We have reviewed the Submissions and Preferred Infrastructure report and provide our comments below.

Serious safety issues with Pedestrian and Cyclist facilities.

Figure 3-9 Key Changes to the Pedestrian and Cycle Network since EIS

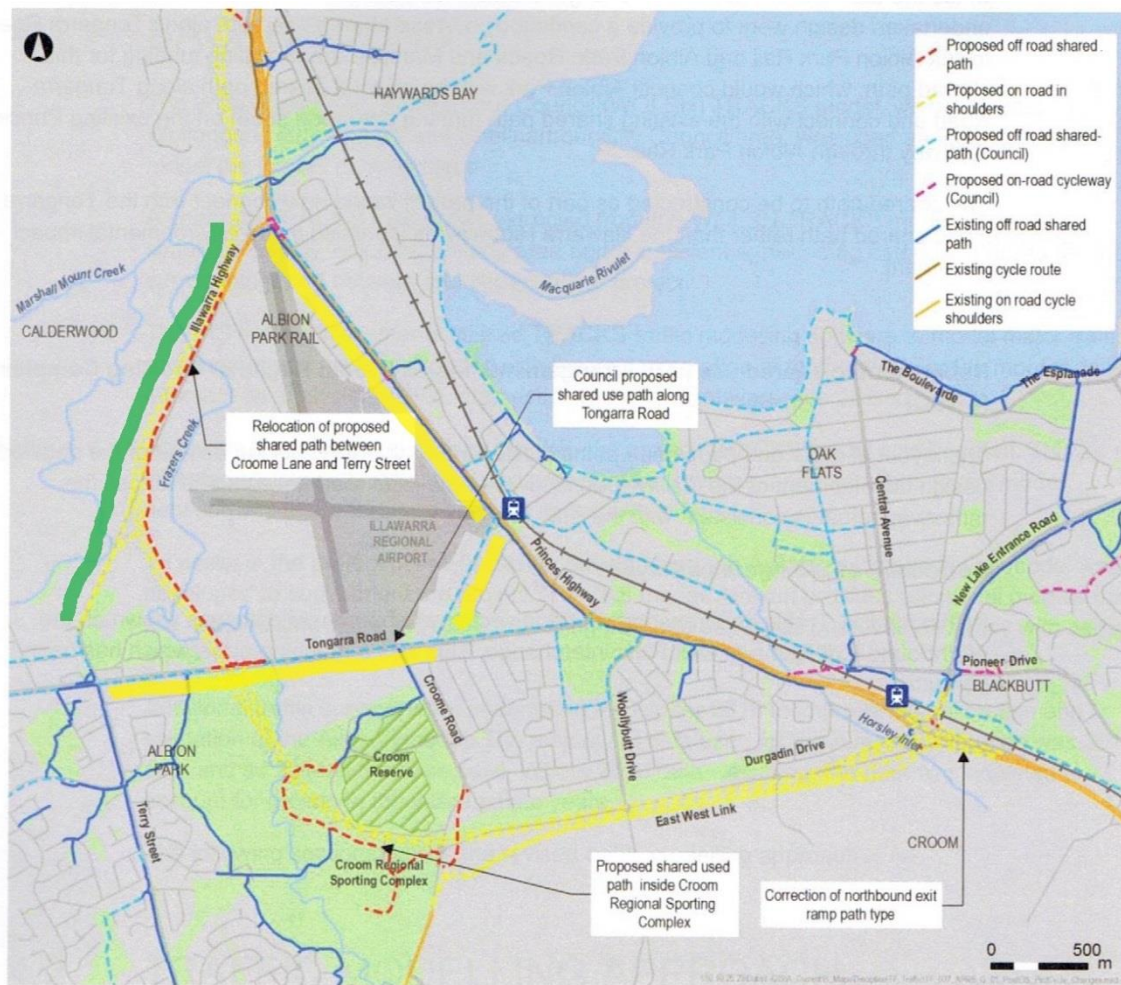
It is important to note that there are alternatives for cyclists. We include a copy of Figure 3-9 from the Additional Traffic and Transport Assessment Report (page 22). Pedestrians and recreational cyclists can use the existing off road shared path along the Princes Highway. This will then join up with the proposed off road shared path on Station Road and then on to the proposed path along Tongarra Road. We have highlighted this route in the diagram with a yellow marker. We note that the Traffic and Transport Assessment report further states "Since the EIS release, Shellharbour City Council in collaboration with Roads and Maritime has undertaken design work to provide a continuous off-road shared-use path along Tongarra Road to link Albion Park Rail and Albion Park. Roads and Maritime are providing funding for this shared path which would connect Albion Park with an off road shared path along Tongarra Road and connect with the existing shared path running north and south on the existing Princes Highway through Albion Park Rail." (page 23 Addendum Traffic and Transport Assessment Report) They further note that the shared path would be constructed as part of the project. So this is not just something Council are thinking of and might not ever get built. It will be available to the public as part of the project. So the needs of the recreational cyclist are already accommodated by these paths. Experienced cyclists will be able to use the cycle paths on the road shoulders of the new motorway as also shown in this diagram. (Highlighted in dark green)

Finally, the construction of a cycleway in this area will add unnecessary cost to the project. We have already noted above how there is an alternate route for cyclists. The duplicate proposed cycle path may be able to follow the existing Illawarra Highway along some of its length but once it swings around toward Tongarra Road it will need to traverse Frazers Creek in two places. Therefore there will need to be two new bridges. As this area regularly floods the bridges will need to be of a durable construction that won't wash away and cause ongoing cost to council. There is no need to waste money on this when there is a guaranteed alternative that is safer for pedestrians and cyclists

We are completely opposed the inclusion of a cycleway in this area.
